Access Compliance Report Public Rights-of-Way (Curb Ramps)

Main Street: HEARTHSIDE_RD Cross Street: WELDON_HEIGHTS Location: SE

ADA ID: RPAT211104141112 Ramp Type: Type 4 - Parallel Initial Pass/Fail: Fail Overall Compliance: No Severity Score: 16

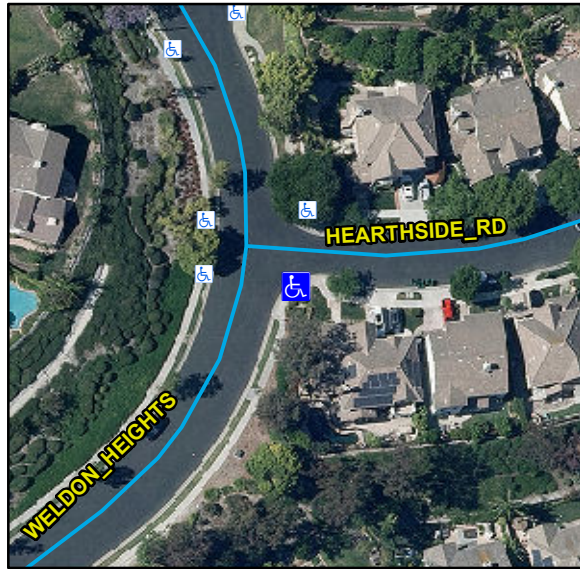
Compliance	Description	Data	Compliance	Description	Data
N/A	Ramp Length LT (in)	84	N/A	Ramp Length RT (in)	75
Yes	Ramp Width LT (in)	53	Yes	Ramp Width RT (in)	54
No	Ramp Run Slope LT (%)	9.5	Yes	Ramp Run Slope RT (%)	0.9
No	Ramp Cross Slope LT (%)	4.2	No	Ramp Cross Slope RT (%)	3
N/A	Landing Present	N/A	N/A	DWS Provided	N/A
N/A	Landing Length (in)	N/A	N/A	DWS Contrast	N/A
N/A	Landing Width (in)	N/A	N/A	DWS Length (in)	N/A
N/A	Landing Run Slope (%)	N/A	N/A	DWS Full Width	N/A
N/A	Landing Cross Slope (%)	N/A		DWS Offset Type	N/A
N/A	Landing Movement Obstructed?	N/A	N/A	DWS Offset Left (in)	N/A
	Landing Movement Type	N/A	N/A	DWS Offset Right (in)	N/A
N/A	Landing Shared	N/A			
N/A	Clear Space	Yes			
N/A	Clear Space To Crosswalk (in)	N/A			
N/A	Marked Crosswalk 1	No	N/A	Marked Crosswalk 2	No
	Crossing 1 Direction	NE		Crossing 2 Direction	NW
N/A	Marked Crosswalk 1 Width (in)	N/A		Marked Crosswalk 2 Width (in)	N/A

Remove & Replace Curb Ramp With Two New Directional Ramps or Equivalent.
